MEMORANDUM

From:	Service Manager Environment	To:	Head of Environment and Planning
Our Ref:	EP/DC/PP/2016/0461	Your Ref:	MP/P/2016/0461
Date:	20 th May 2016

Location: O. S Grid Ref: 353 512 22 Bryn Estyn Road, Wrexham.

Development: Demolition of Existing Dwelling, Outline Planning Application for Residential Development (up to 4 no. dwellings) and Construction of New Access.

7.5t Panel Van
 Overall Length
 Overall Width
 Overall Body Height
 Min Body Ground Clearance
 Track Width
 Lock to Lock Time
 Kerb to Kerb Turning Radius

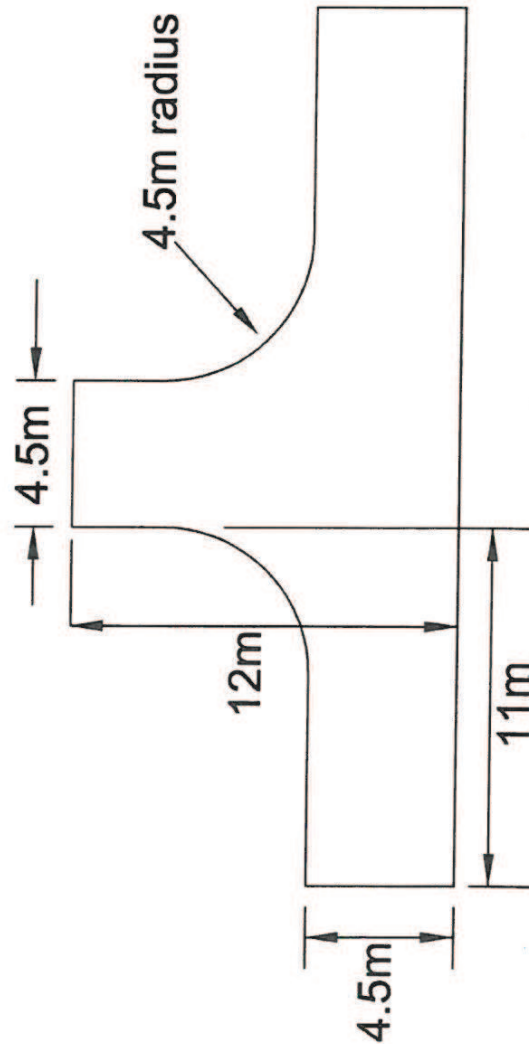
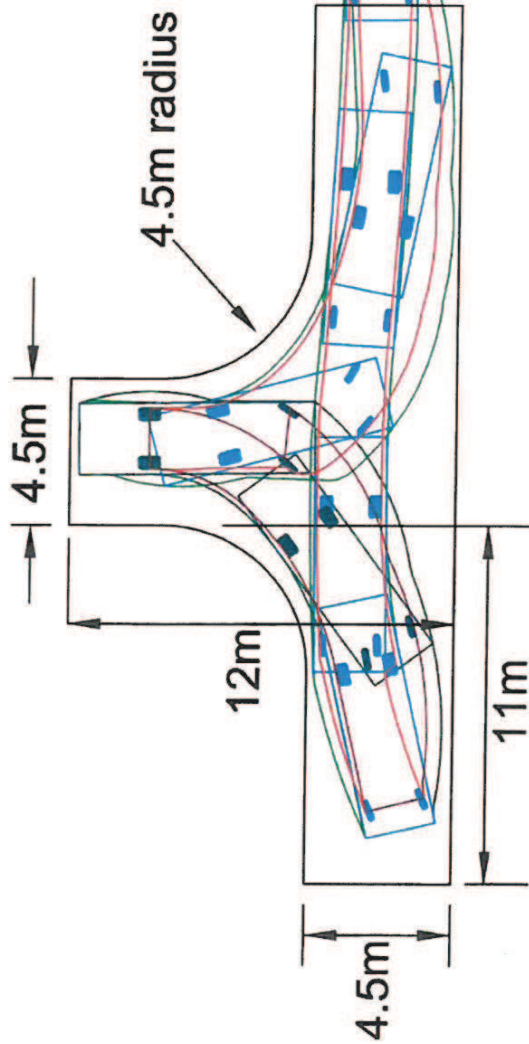
I would recommend that a suitable turning head is provided that can accommodate the turning movements of a medium sized delivery vehicle (see attached detail). This detail has not been indicated / annotated on the submitted layout plan.
